**AYRE
CHAMBERLAIN
GAUNT**

NMA Report

Our ref: 197_REF_813

STAMFORD ROAD NMA REPORT

197_PLN_200 GROUND FLOOR PLAN_SUMMARY OF CHANGES

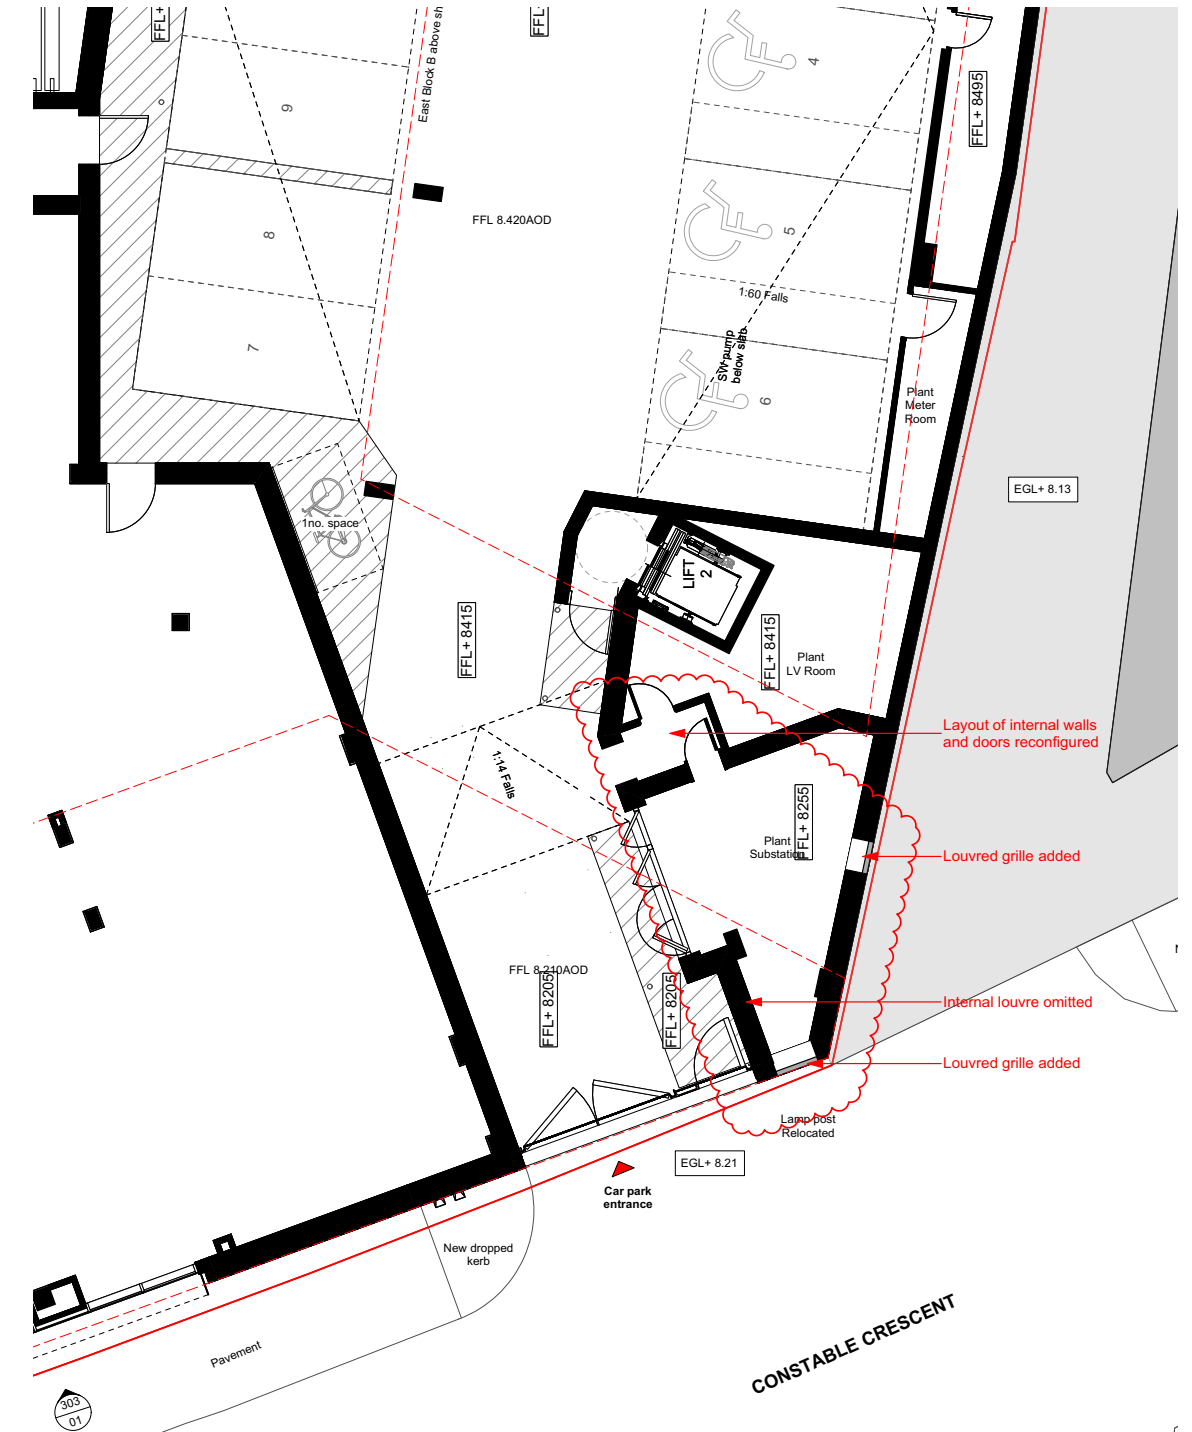
Changes proposed to substation doors, and louvred vents:

- The proposal to vent the substation without any openings on the external walls has proven to be unfeasible due to technical constraints.
- The proposals now seek to remove the internal louvred vent and to add a louvred grilles to the external walls.
- The louvred grilles are proposed strategic positions to offer cross-ventilation to the sub-station room.
- Minor internal alterations are proposed to suit access requirements for the landlord and UKPN.

197_PLN_201 FIRST FLOOR PLAN_SUMMARY OF CHANGES

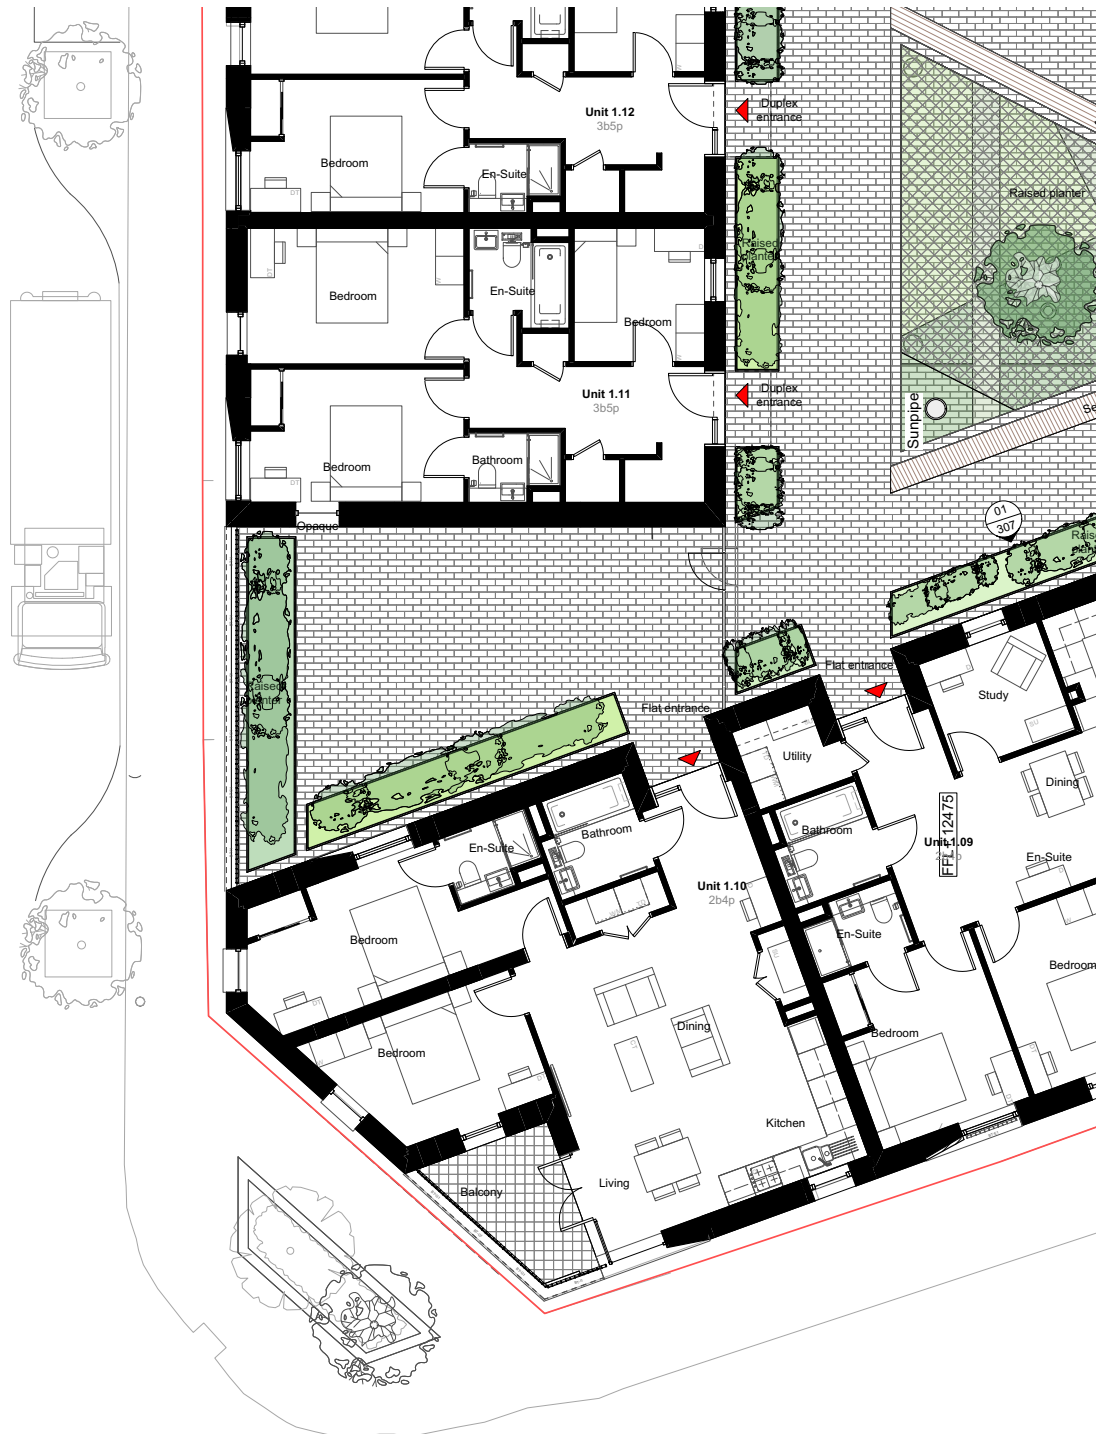
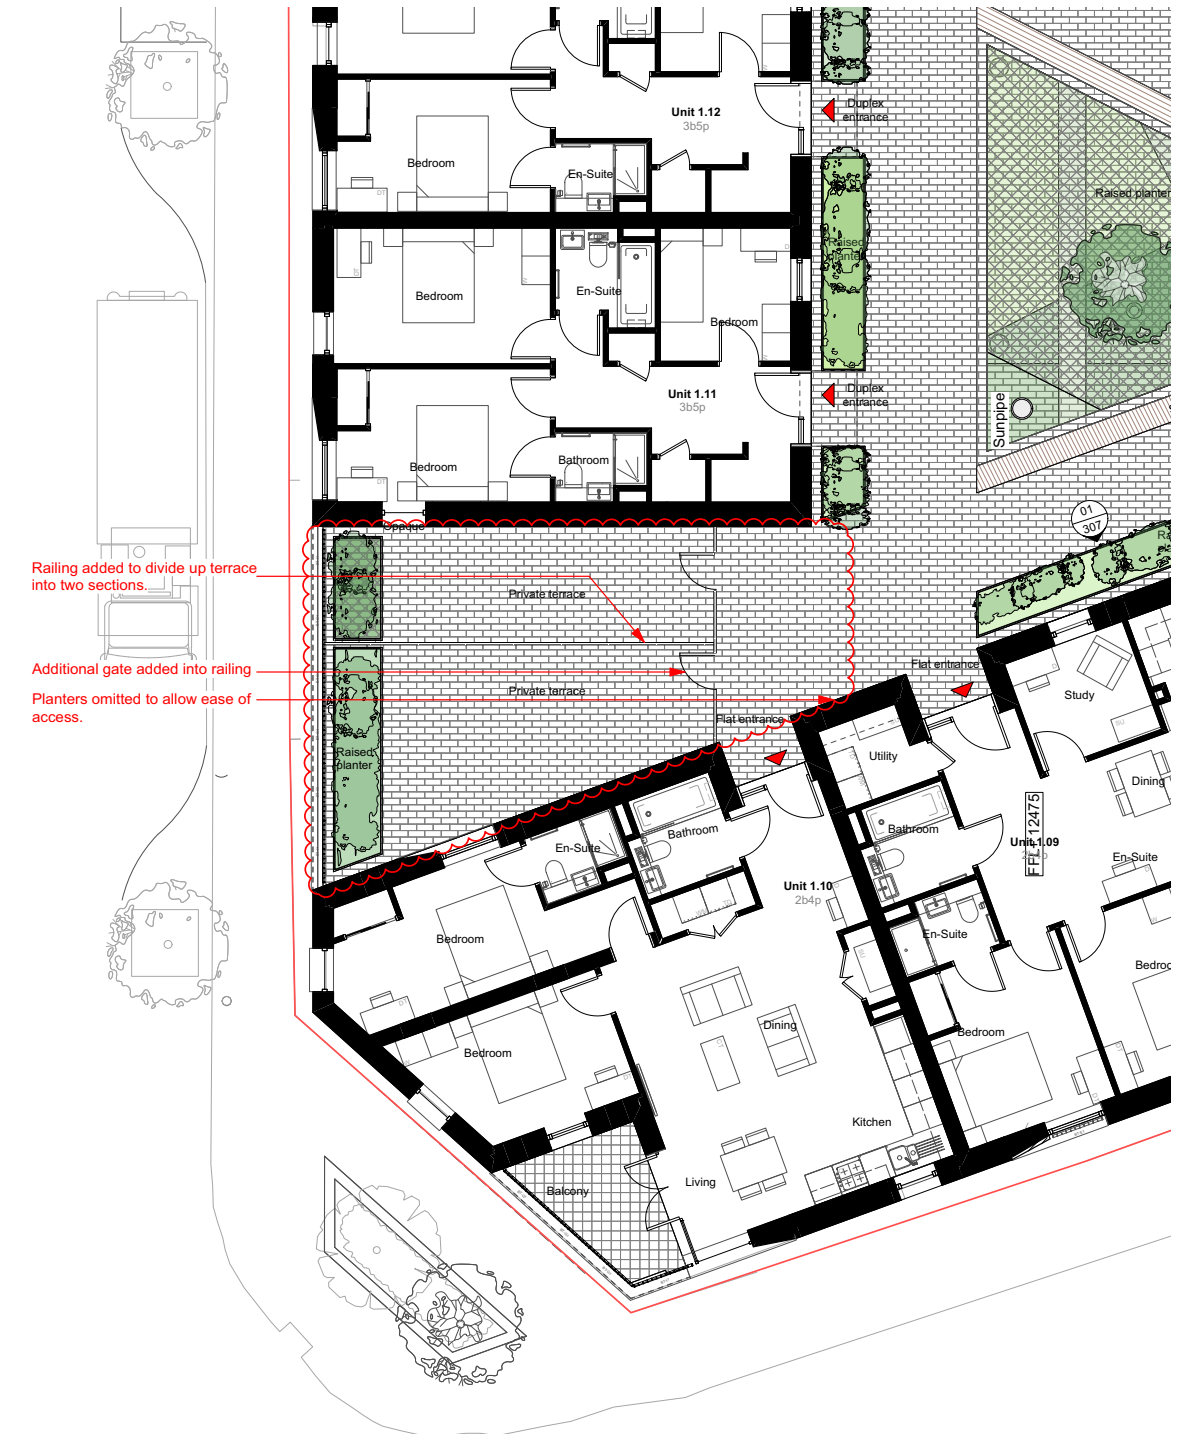
Changes proposed to external terrace between units 1.10 and 1.11:

- External terrace to be divided into two areas, each to serve the adjacent unit.
- Additional gate and railings to match the already proposed railings in height, design and finish.

197_PLN_205 FIFTH FLOOR PLAN_SUMMARY OF CHANGES

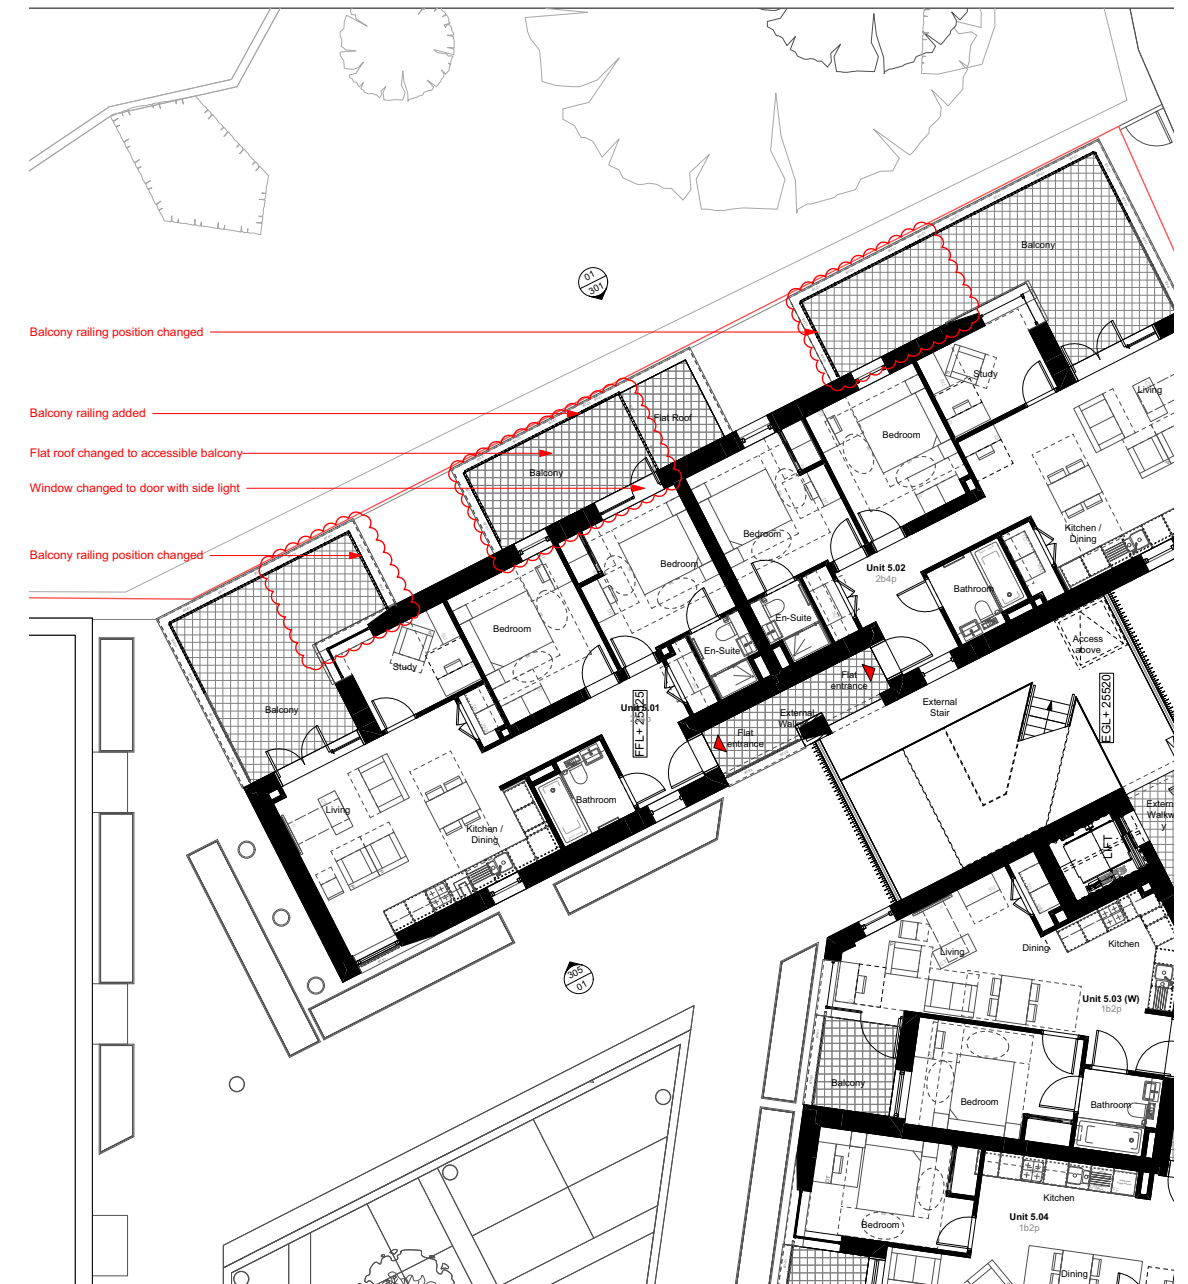
Changes proposed to balconies to units 5.01 and 5.02:

- In order to avoid difficulties with accessing small sections of roofs for maintenance, which was going to require abseiling from the roof above, changes are proposed to the balcony arrangements at level 5 on Block A.

- In particular, the railings to the two corner balconies, are to be re-positioned to avoid creating inaccessible roof areas.

- The central section of flat roof is to become an accessible balcony for unit 5.01 with new railings proposed to match the adjacent balconies.

- Access to the new balcony will be via a new external door from a bedroom which is proposed to replace a window in this location.

- These changes represent a reduction of work at height risks and are an improvement under CDM considerations

197_PLN_300 WEST ELEVATION_SUMMARY OF CHANGES

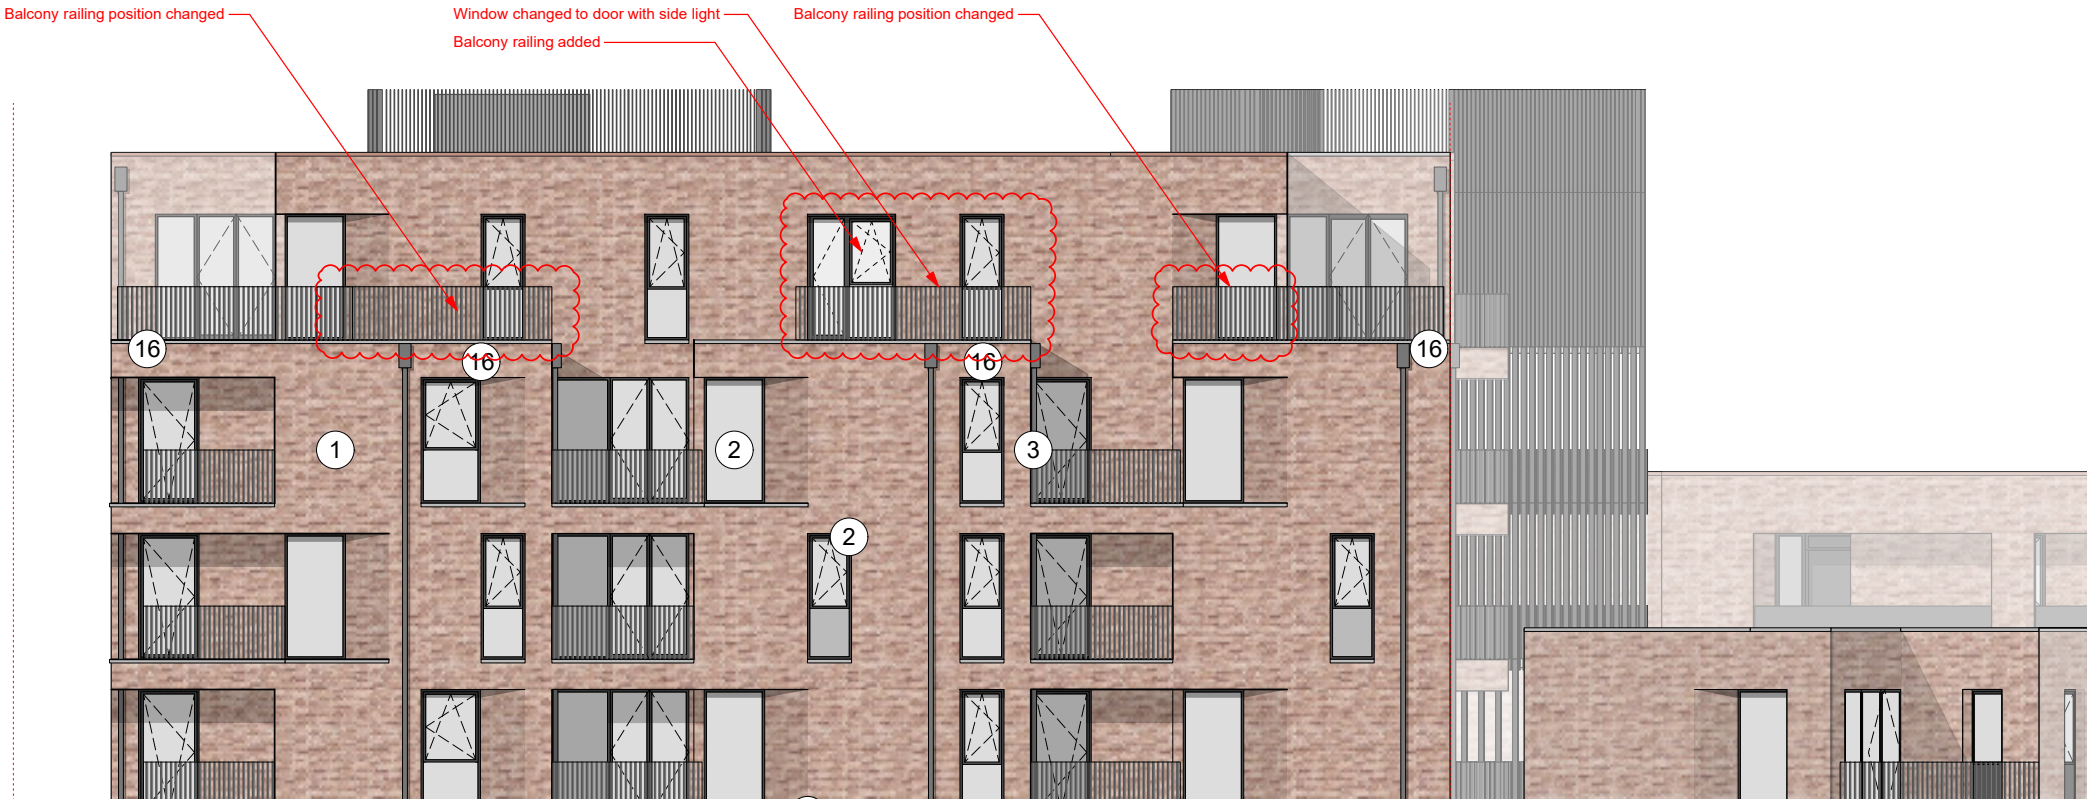
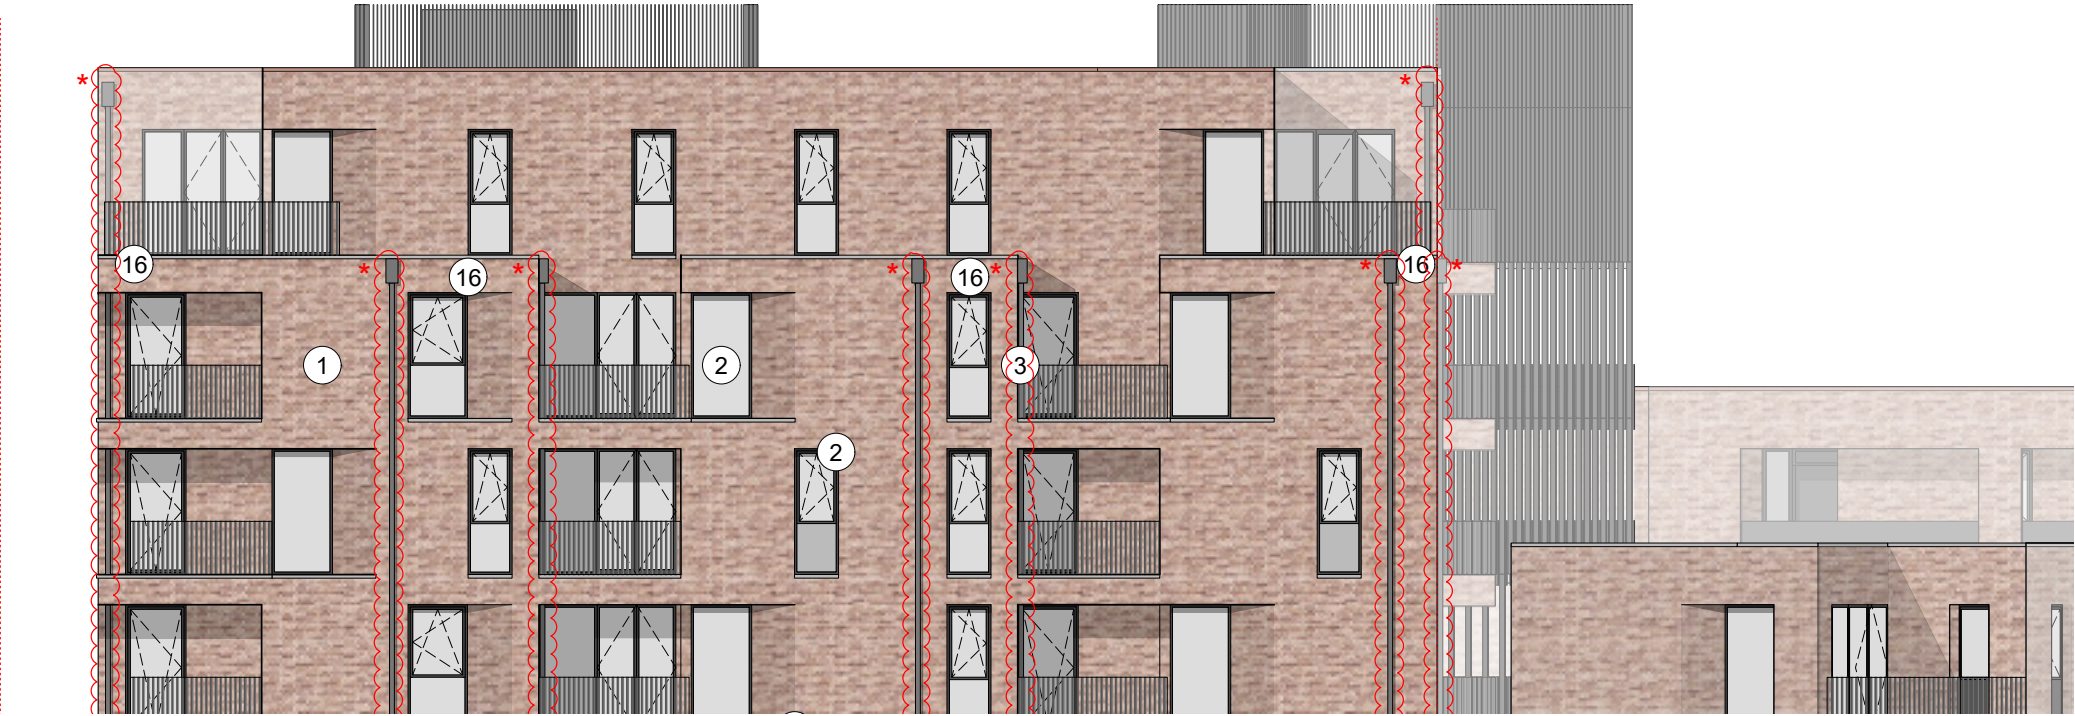
- At fifth floor level, changes are proposed to the balcony railings and a door is proposed for balcony access. These changes are described in more detail on page 5.

- At first floor level, the operation of 10 no. Block D windows is proposed to change from tilt/turn to tilt inwards only. No other changes to fenestration.

- At ground floor level, the position of one of the solid spandrel panels is relocated to provide a mounting position for the door entry intercom system.
